City Commission Reconsideration Of Petition DB-18-17 SUB

Design Plat Review for Oaks Preserve Cluster Residential Subdivision, to create 295 single-family residential lots on 95.17 acres. Located West of SW 50th Terrace, between SW Archer Road and SW 57th Avenue.

Legistar No. 171022

City Commission Review Petition DB-18-17 SUB

PROPOSED TO
SIC TRAIL
ROUTE/CROSS
ACCESS EXHIBIT

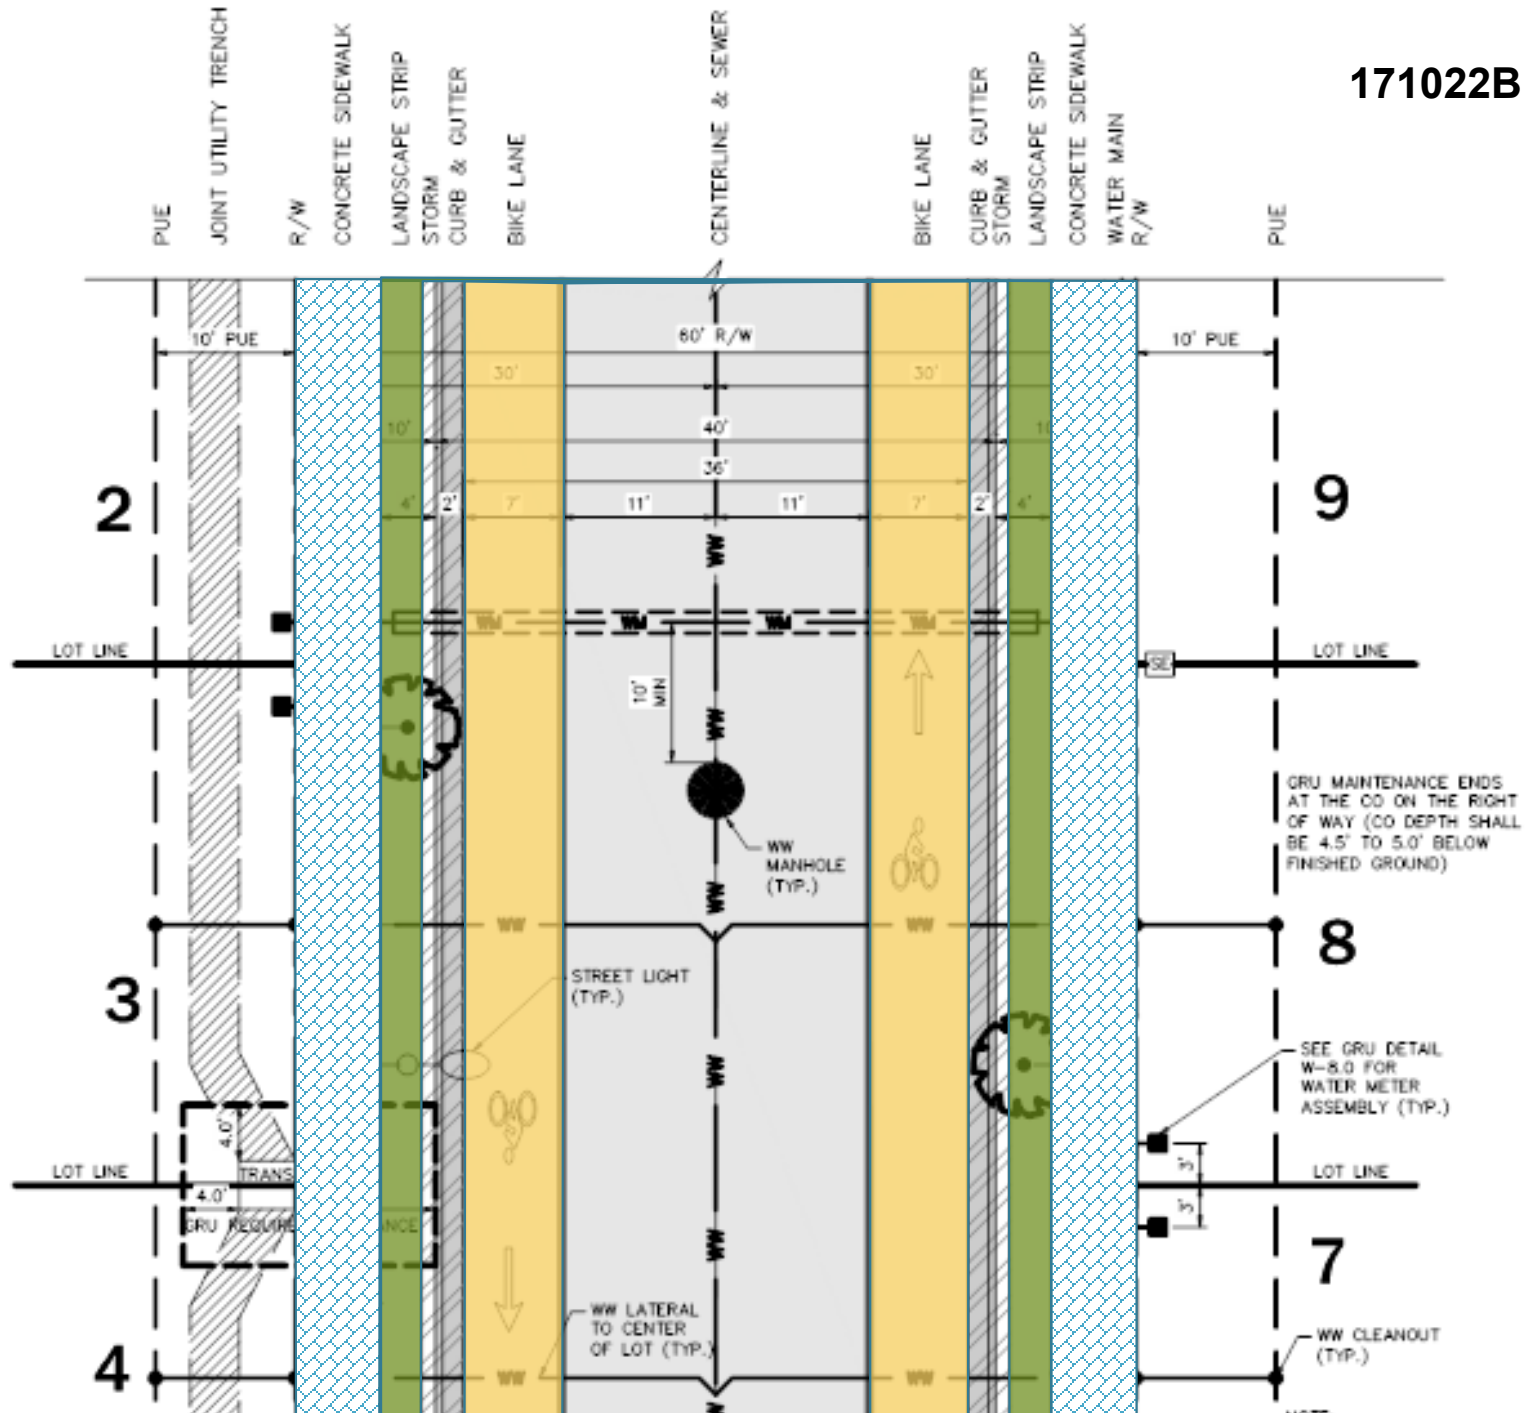
1. **The north/south trail: Design and Configuration**
2. **Width of right of way corridor between lots 135 and 136**
3. **Phasing of the subdivision**
4. **Modification of DRB Condition 14**
5. **A 7-foot wide buffered bike lane on Road “Q”;**

60' RIGHT-OF-WAY WITH BIKE LANE
TYPICAL UTILITY ALLOCATION CROSS SECTION - SECTION F-F
 DESIGN SPEED: 35 MPH N.T.S.

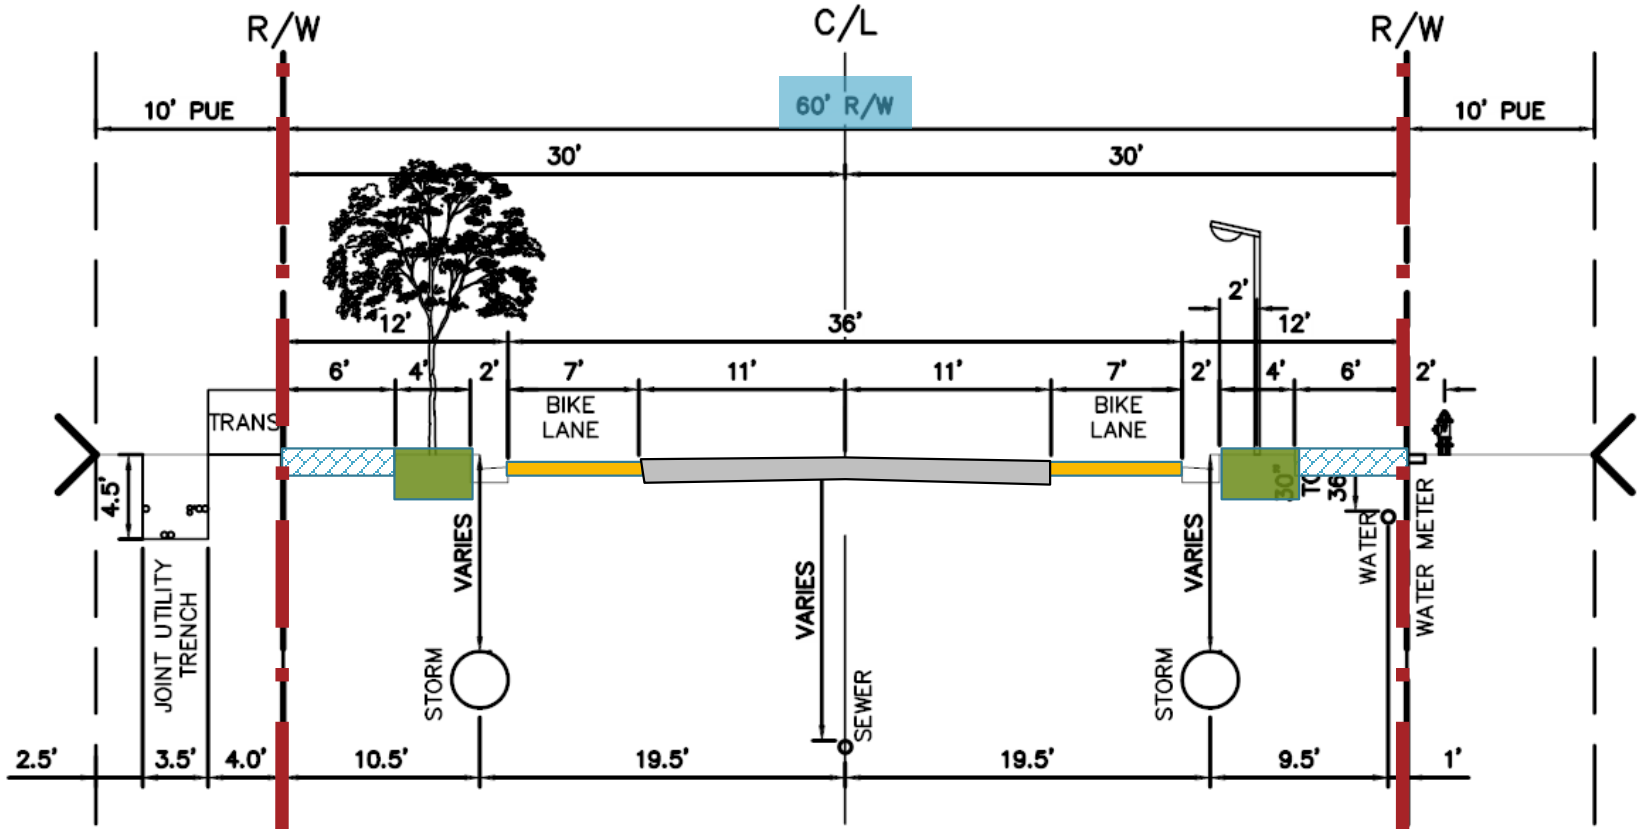
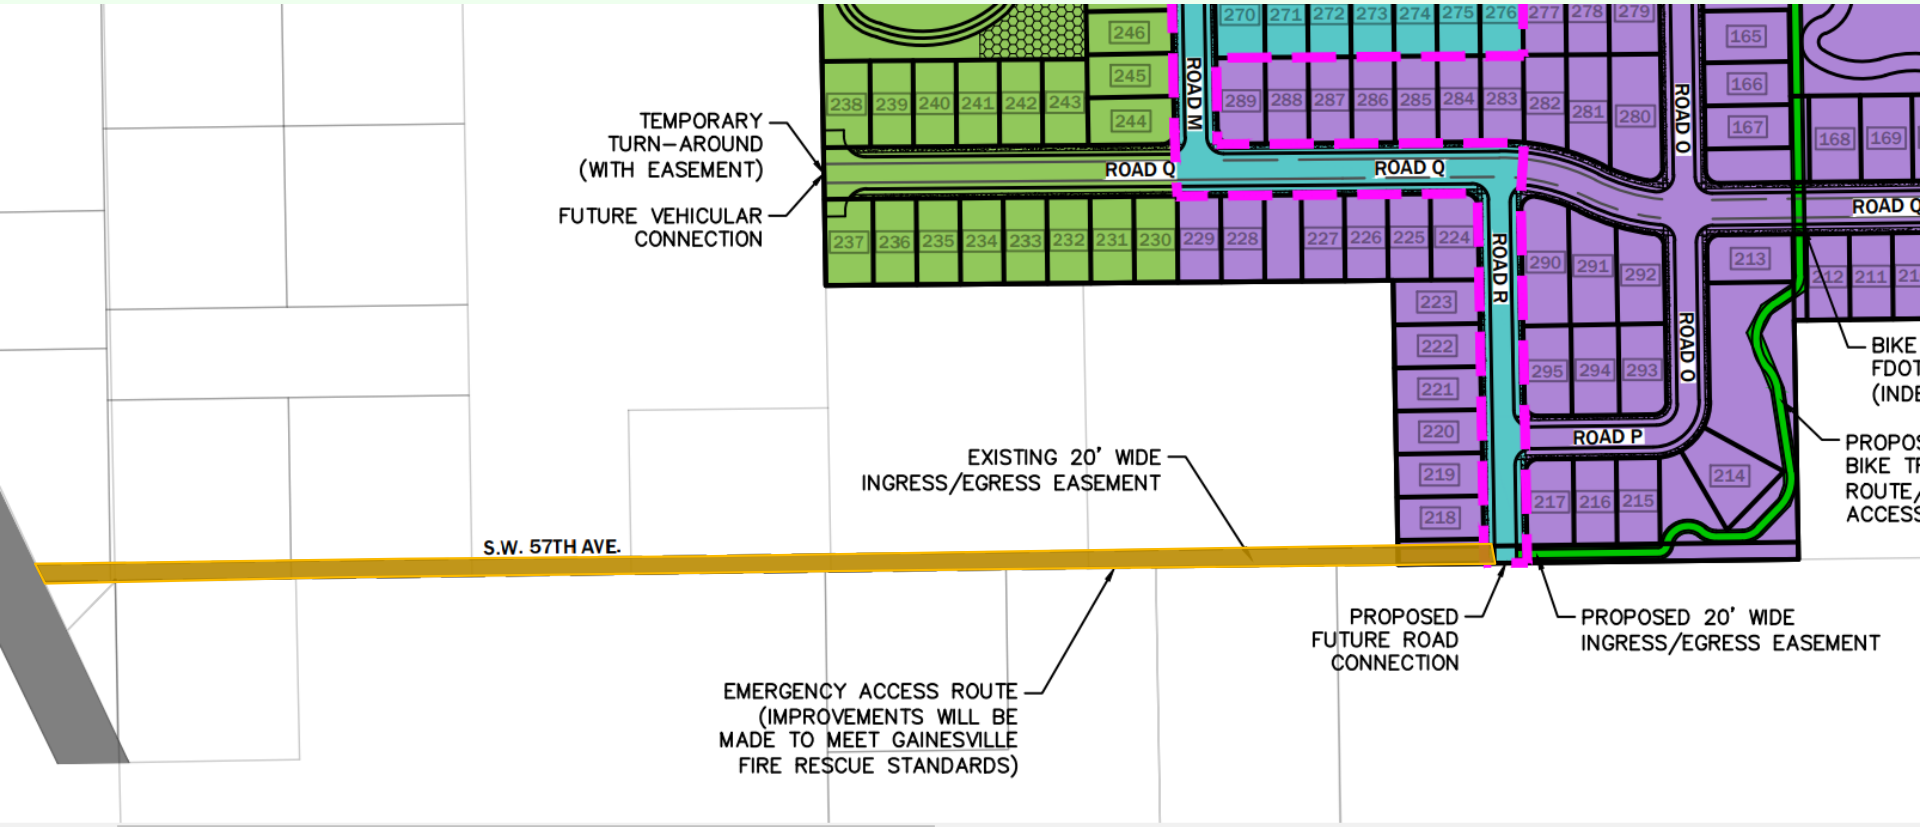
1. The north/south trail shall be reconfigured to run as an independent route and shall not be designed as a shared path within the proposed rights-of-way. The trail shall be designed as a 10-foot wide multi-use trail and shall be routed at the back of lots.
2. The right of way corridor provided between lots 135 and 136 for access to tax parcels 06952-001-000 and 06952-003-000 shall be expanded to a minimum width of 50 feet.
3. Prior to approval by the City Commission, the subdivision shall be designed to show a second or third phase with a third approved external connection to the closest officially paved roadway.
4. **Condition 14 shall be modified as listed below:**

Roadway
Cross Section

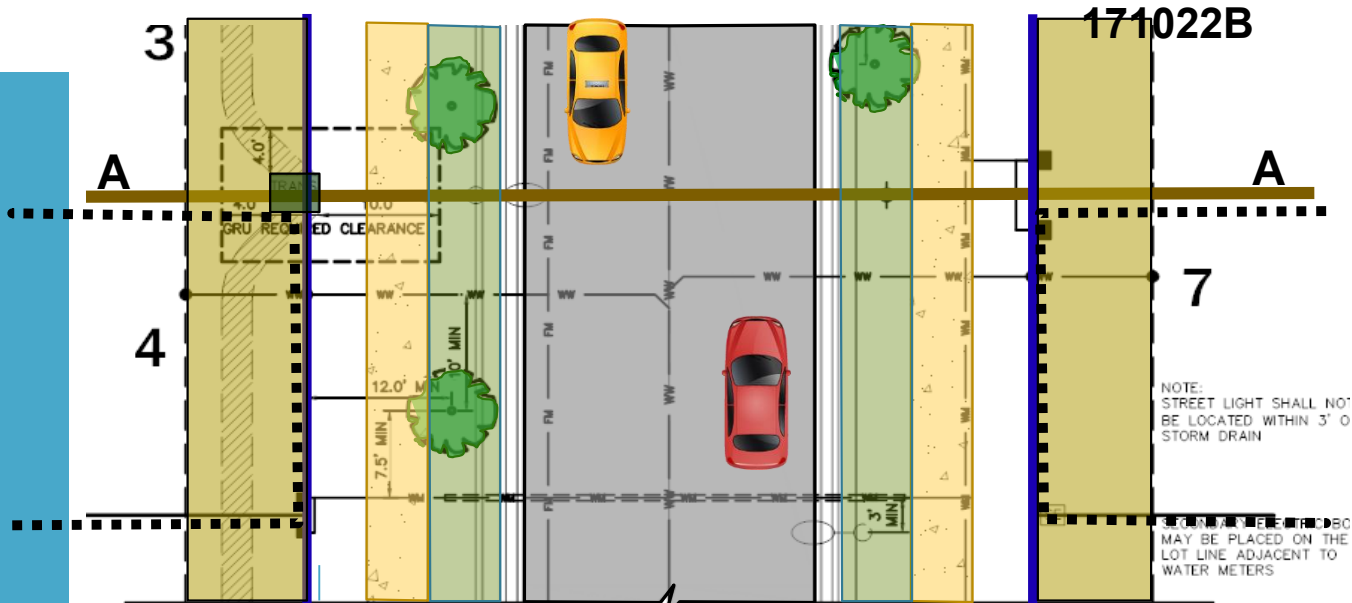
Construct a bike trail along the southernmost east/west, "Road Q", plus a minimum, 8-foot wide multi-use trail
